PARKWAY PLACE SUBDIVISION

APPLICATION NUMBER 14 DATE December 4, 2008

REQUEST Subdivision

DETAIL SITE PLAN

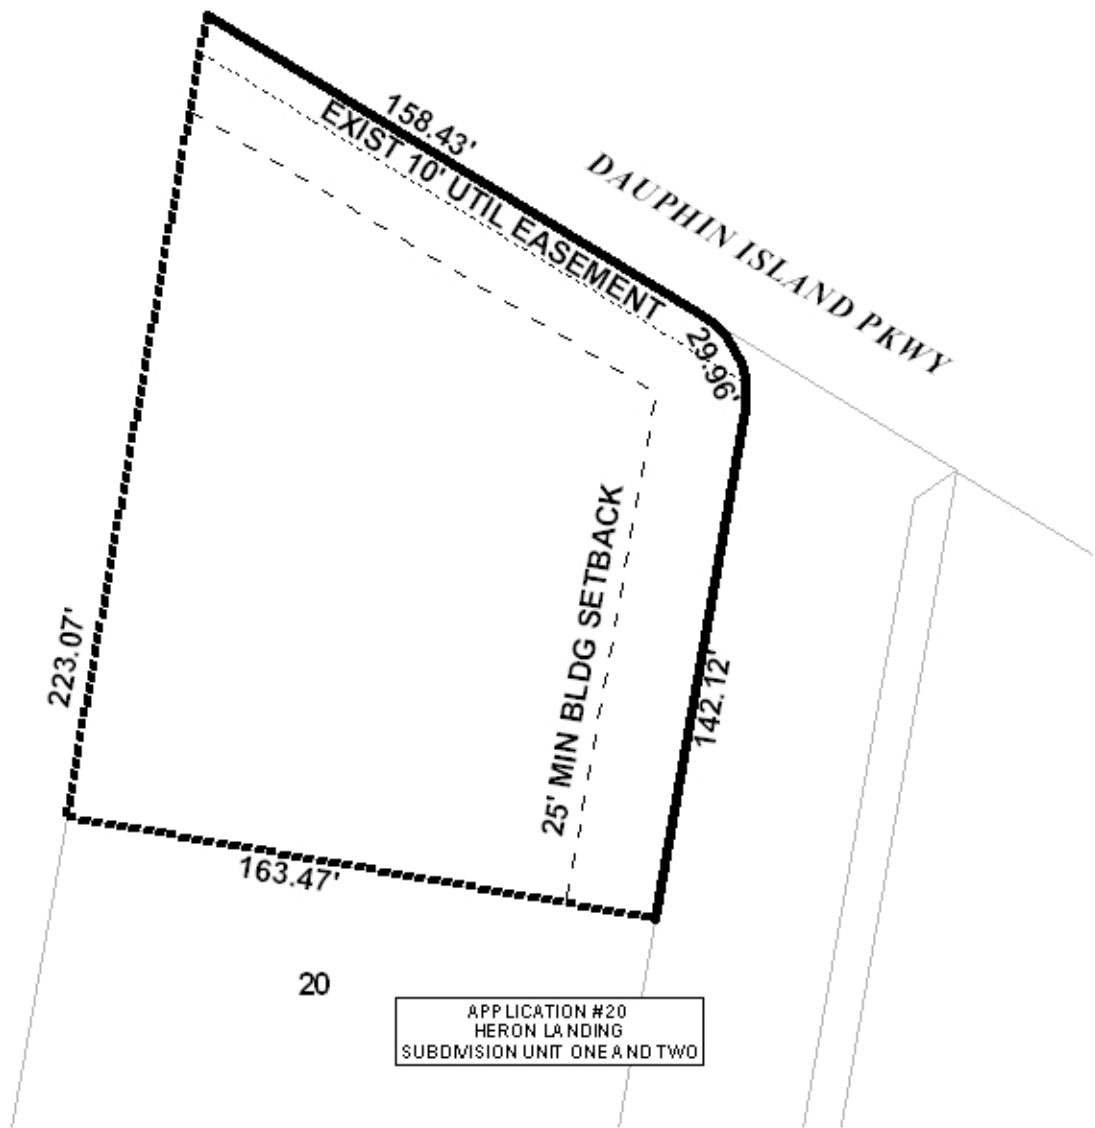
To the East, the site fronts a proposed minor street (currently under construction) with sufficient right-of-way. To the North, the site fronts Dauphin Island Parkway, a major street, but it is not labeled with its right-of-way width. Therefore, staff is unable to determine whether dedication will be required. The Major Street Plan requires a minimum 100' right-of-way for all Major Streets. The applicant should revise the plat accordingly.

The site has approximately 158 and 142' of frontage, respectively, along Dauphin Island Parkway and the proposed minor street. As a means of access management, a note should be place on the final plat stating that the lot is limited to one curb cut to each street, with the size, location, and design to be approved by Traffic Engineering and conform to AASHTO standards.

- 1) Completion of the rezoning process prior to the issuance of any permits or land disturbance activities;
- 2) Dedication, if applicable, of sufficient right-of-way to provide 50' as measured from the center line of Dauphin Island Parkway;
- 3) Placement of a note on the final plat stating that the site is limited to one curb cut to each street, with the size, location, and design to be approved by Traffic Engineering and conform to AASHTO standards;
- 4) The applicant receive the approval of all applicable federal, state and local environmental agencies would be required prior to the issuance of any permits or land disturbance activities; and
- 5) Placement of a note on the plat stating that the site must be developed in compliance with all local, state and Federal regulations regarding endangered, threatened or otherwise protected species.
